**Re: 5740 BAYSHORE ROAD SEZ AND REZ  
2<sup>nd</sup> INSUFFICIENCY RESPONSE LETTER  
REZ2025-00005 and SEZ2025-00007**

Enclosed please find responses to your insufficiency letter dated *January 6<sup>th</sup>, 2026*. The following information has been provided to assist with the approval process:

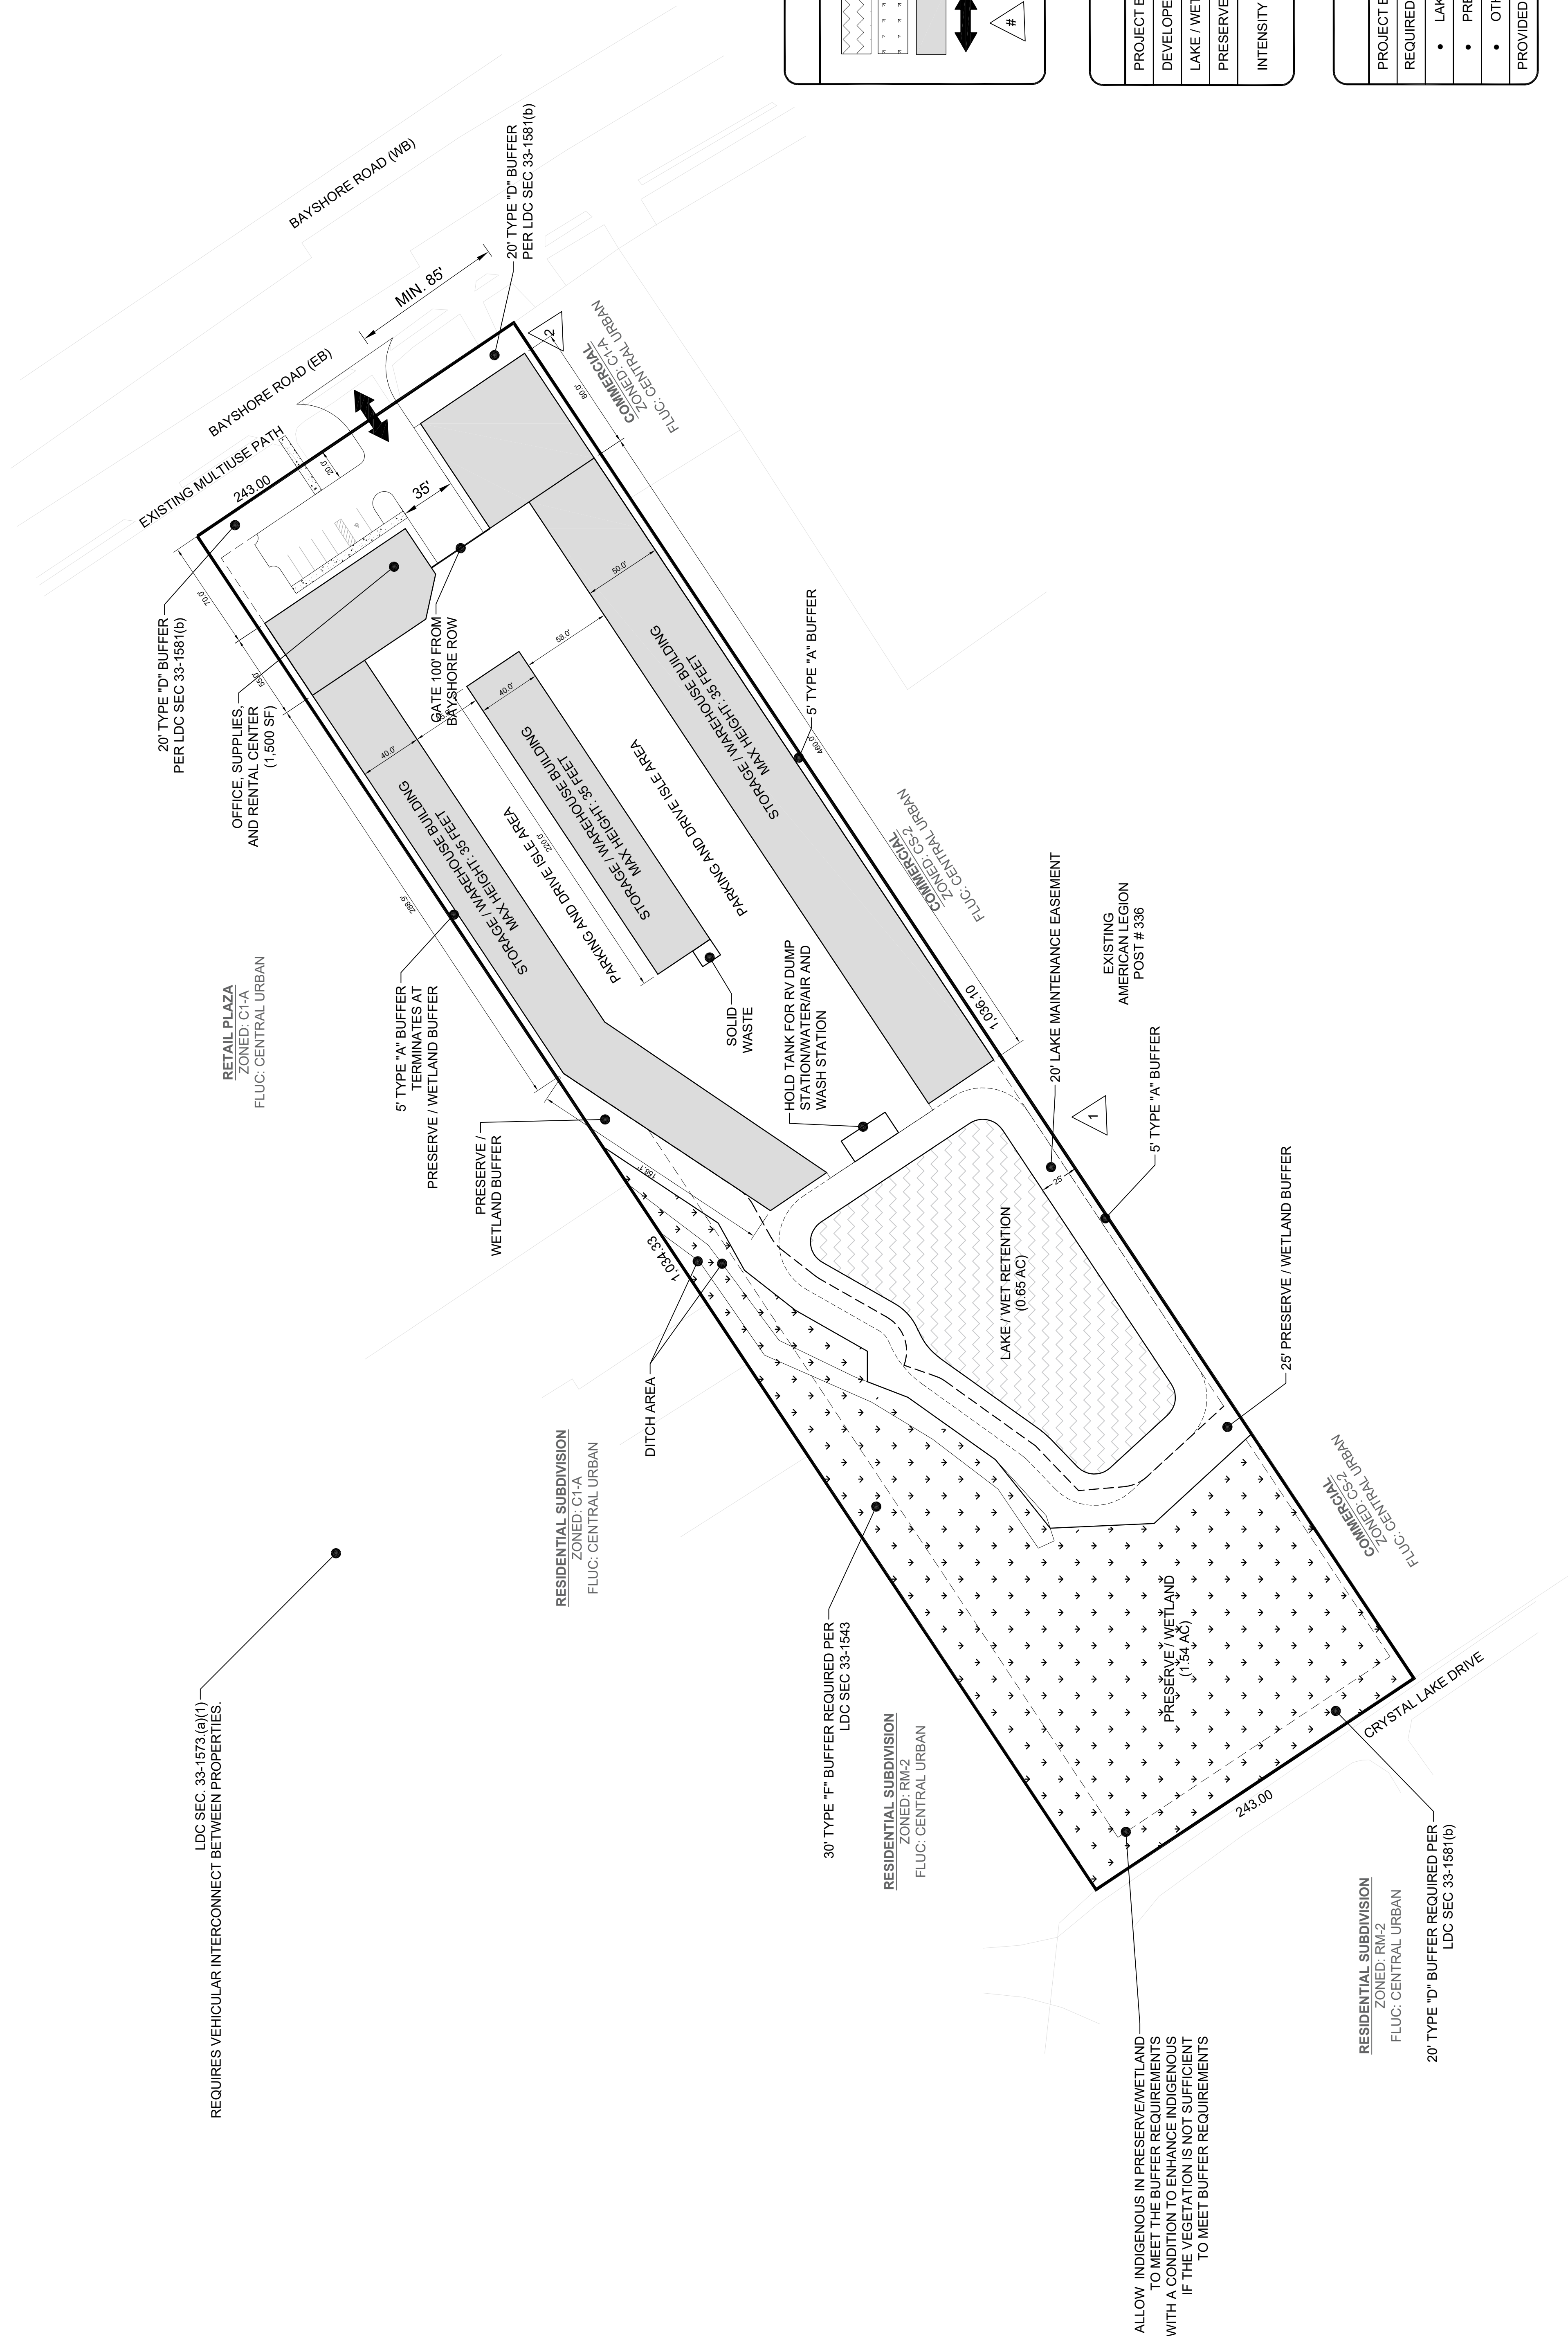
Staff appear to have identified easements not acknowledged by the applicant; instrument number 2009274, OR BK 1811 /PG 1101. Revise the site plan to show all easements.

The applicant has stated that the 30-foot type-f buffer required under LDC 33-1543 will overlap within the indigenous open space preservation. Portions of this area are an existing surface water feature which appears to drain onsite and offsite flows, and which is supported by an offsite retaining wall. Clearly delineate the extent of the surface water feature on the site.

Provide additional evidence to support the applicants position that the water feature identified during site inspection does not meet the definition of Natural Waterway or revise the MCP to show the 50-foot buffer on the plan.

The applicant has stated they will seek a deviation from 10-329(d)(1)a., identify the location of the proposed deviations on the site plan.

**RESPONSE: The easement was not identified on the furnished title.**

**RESPONSE: The ditch area, or extent of the surface water feature, has been shown on the site plan.**

**RESPONSE:** The area has been identified as a ditch per the Atwell vegetation map as evident that it connects to an offsite retaining wall and drainage swale that runs parallel to the abutting drainage pond that serves the abutting commercial shopping plaza. The ditch/swale terminates at Bayshore Road and continues unimpeded through the subject property as exhibited in the graphic below. This does not seem to meet the definition of a natural waterway.

**RESPONSE:** The deviation triangles are on the site plan.
